1. No Meeting Agenda

1.I. Viewpack

37 OCEAN AV ROOF TOP SOLAR MH.PDF
65 CENTER ST- HARDSCAPING.PDF
24 BARTLETT FARM RD- OB SUB FOR 6-30-20.PDF
37 OCEAN AV ROOF TOP SOLAR COTTAGE OB SUB FOR 6-30-20.PDF

HOUSE ELEVATIONS

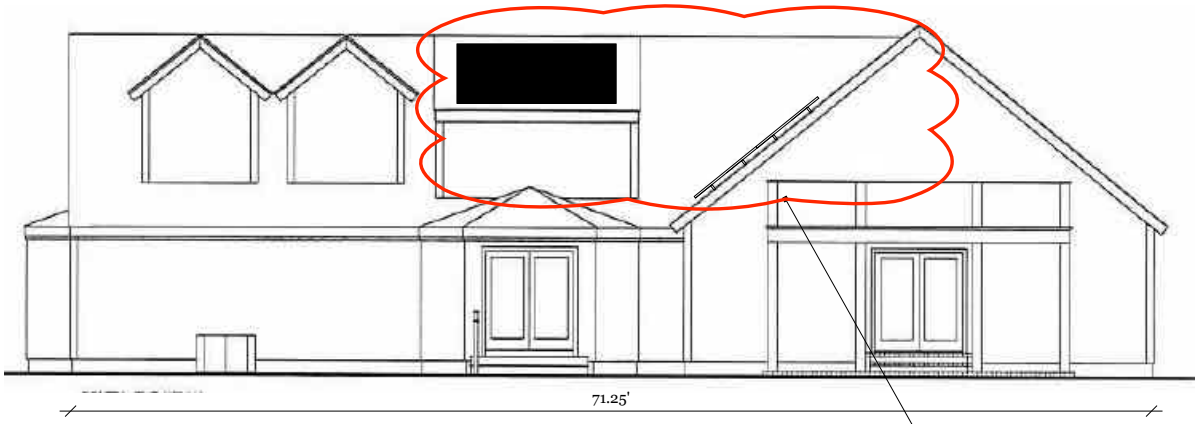
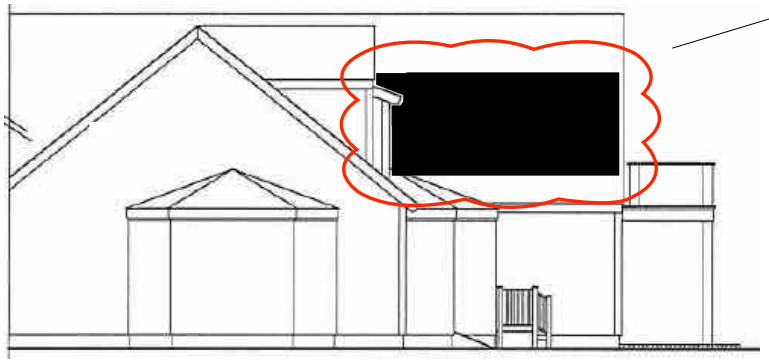
Voting	Pohl, Coombs, McLaughlin, Oliver, Welch
Alternates	None
Recused	None
Documentation	Architectural elevation plans, site plan, photos, correspondence, manufacturer spec sheet, historic documentation, advisory comments, and *Building with Nantucket in Mind*.
Representing	Tobias Glidden, ACK Smart
Public	None
Concerns (7:08)	**Glidden** – Read into the record a letter from Kate Heller O'Reilly; reviewed changes made per previous concerns. Willing to move the cottage panels to the west elevation. **McLaughlin** – He'd like to view this; there's a lot if information to absorb. Doesn't support arrays in the old historic districts (OHD). **Backus** – This has been heard a couple of times, might not want to hold this up for a view of the cottage, which is a new application. Read her comments previously submitted into the record; there is a section within *Building with Nantucket in Mind* that talks about the proper placement of solar panels. The garage is circa 1980s. **Oliver** – The orientation points are wrong. **Welch** – The cottage west roof plane parallel to Ocean Avenue is the appropriate location for the panels. **Coombs** – On the cottage, if the panels go up there, they should be laid straight, not ell-shaped. **Pohl** – This is in the 'Sconset OHD and we want to ensure lack of visibility. Moving the panels to the cottage west elevation is a good idea. The panels on the west elevation of the main house will be visible from Linden Avenue.

Motion	**Motion to View the main house and hold for revisions. (McLaughlin)**
Roll-call Vote	Carried 5-0//Oliver, Welch, Coombs, McLaughlin, and Pohl-aye Certificate #
Motion	**Motion to View the cottage and hold for revisions. (McLaughlin)**
Roll-call Vote	Carried 5-0//Oliver, Welch, Coombs, McLaughlin, and Pohl-aye Certificate #

1 Site Plan - Hardscaping
1 : 60

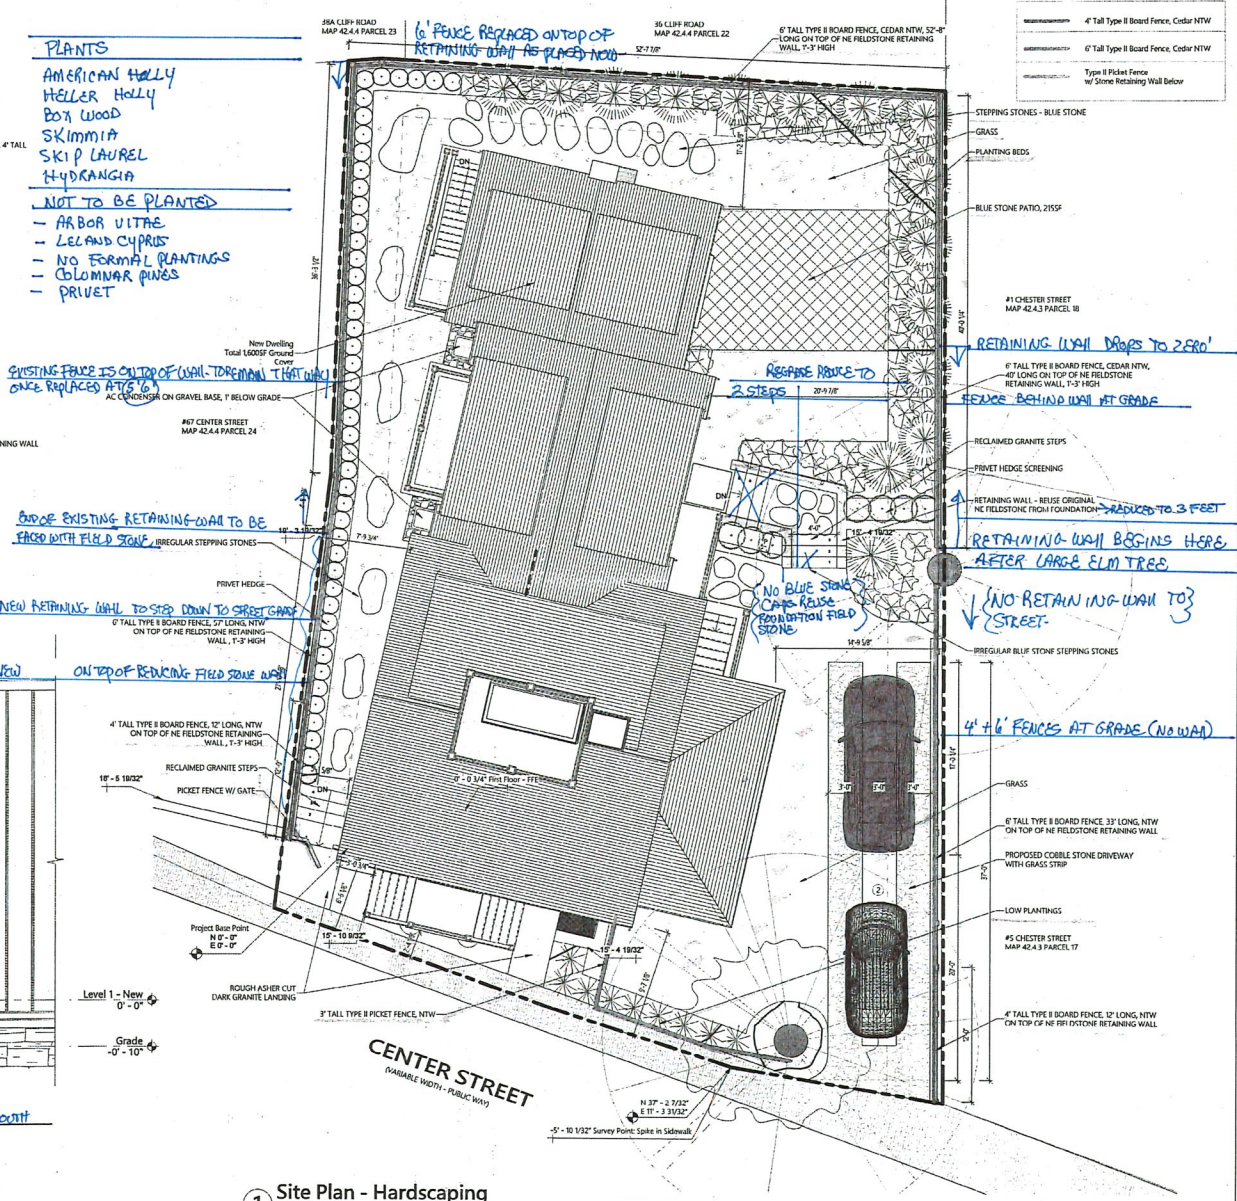
Voting: Pohl, Coombs, McLaughlin, Camp, Oliver
Alternates: Dutra
Recused: None
Documentation: Landscape design plans, site plan, photos, and advisory comments.
Representing: Linda Williams
Public: None
Concerns (5-45): **Williams** – Presented project; bluestone patio irregular cut; there is no arbor; retaining walls not as tall as rendered.
Backus – Read comments: formality is okay with Greek revival elements.
Oliver – There's a lot of fence but it's an improvement over what was there. Hope the retaining walls will be screened by vegetation. Asked for some fence to be 5&1.
Camp – Okay with most everything. Asked height of "arbor view" fieldstone walls; eliminate the bluestone caps. She thinks 5&1 fences draw the eye while solid board is simpler.
McLaughlin – No comments.
Coombs – Agrees about reducing the retaining wall; wants to see what will be planted there; would prefer less formal planting plan due to age of the house. Agrees with Ms. Camp about the simpler board fence.

Pohl – A distinctive aspect is the stone walls acting as railing at the "arbor view" steps; right wall is 2-feet taller than it needs to be. His main concern is the amount of stone wall; but that can be cut down.
Discussion about height of retaining wall with the fence on it.
Motion: **Motion to Hold for revisions. (Camp)**
Roll-call Vote: Carried 5-0//Coombs, Oliver, McLaughlin, Camp, and Pohl-aye Certificate #

EXTERIOR ELEVATIONS

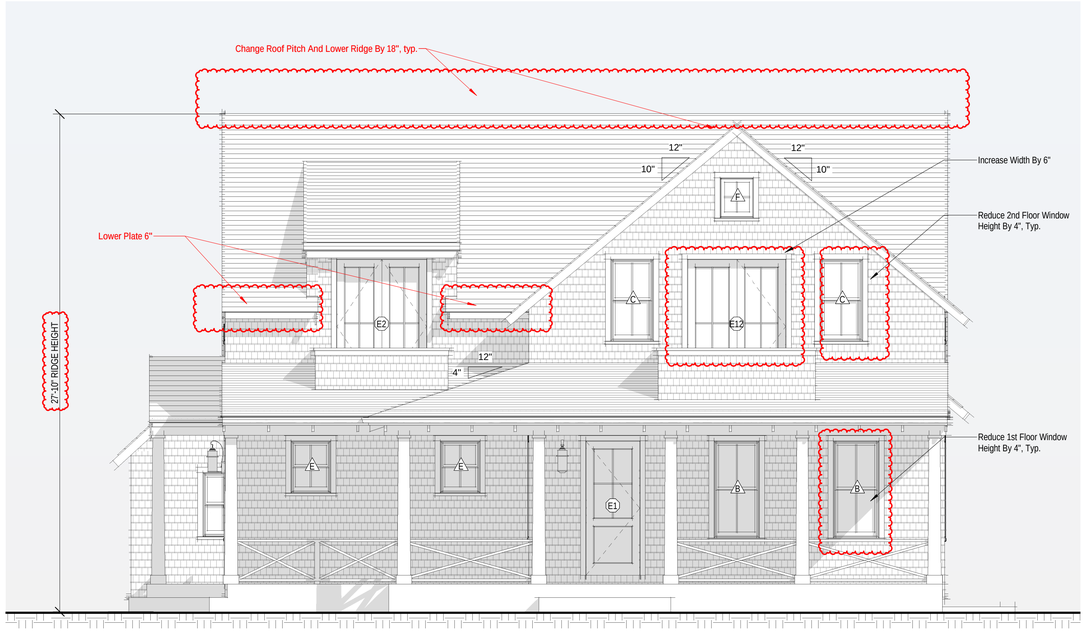
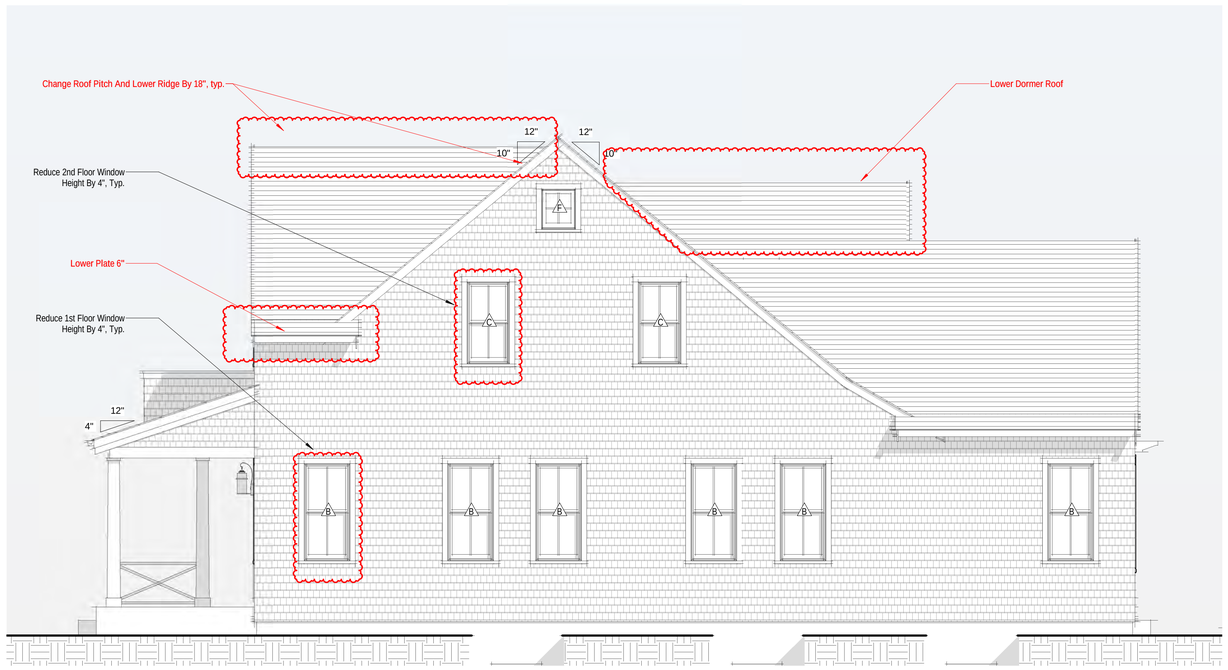
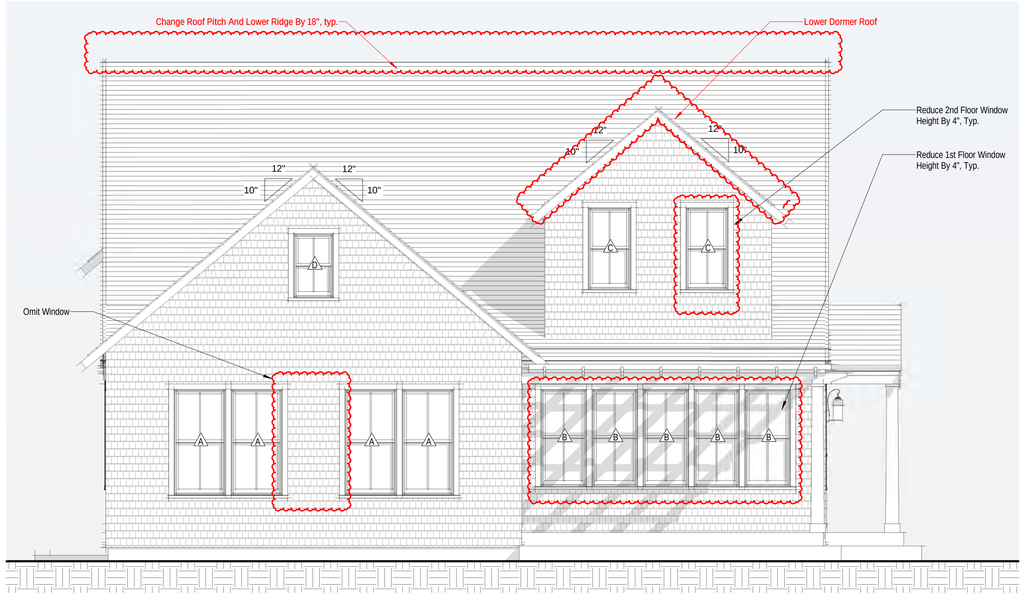
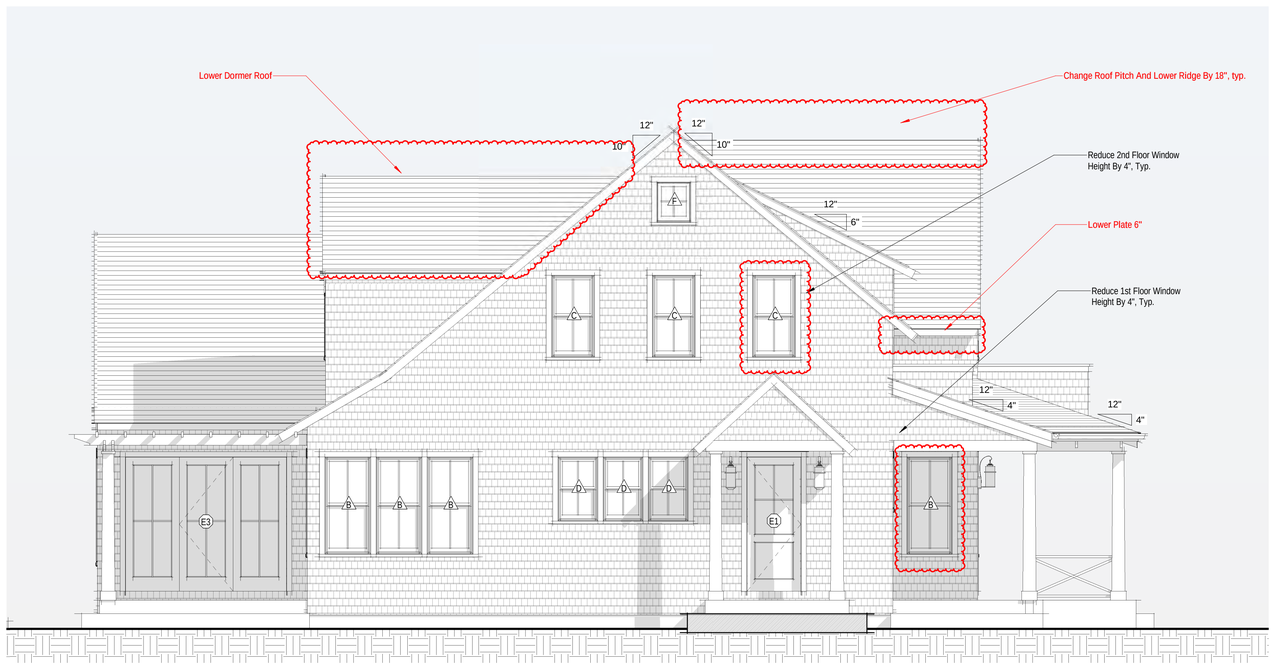
Voting	Pohl, Coombs, Camp, Oliver		
Alternates	None		
Recused	None		
Documentation	Architectural elevation plans, site plan, and photos.		
Representing	Matt MacEachern, Emeritus Development		
Public	None		
Concerns (4:50)	**MacEachern** – Reviewed changes made per previous concerns; anticipating heavy vegetation along the west side. **Oliver** – It's hard to tell scale without some sort of measure but this is larger than houses around it and completely visible. Would prefer the south elevation faced Bartlett Farm Road rather than Mioxe Way. East elevation, if the dormer were smaller, it would help mitigate the size of the house. Her approval would require screening. Would like to see height poles. **Coombs** – The building is too tall; needs to come down. This is a rural area and should follow the rural guidelines. **Camp** – Agrees with what's been said; if this were shrunk down, the saltbox idea would fit better. North elevation, the gable dormer overpowers the façade and the windows are swimming in a wall; preferred the shed dormer. **Pohl** – Shares the expressed views. North elevation dormer, window sills tower above the roof below; suggested pushing the dormer back so the windows are more rooted to the roof. Could reduce the plate height. Agrees about height poles.

Motion	**Motion to View with height poles at each end of the main gable and hold for revisions. (Camp)**		
Roll-call Vote	Carried 4-0//Oliver, Camp, Coombs, and Pohl-aye	Certificate #
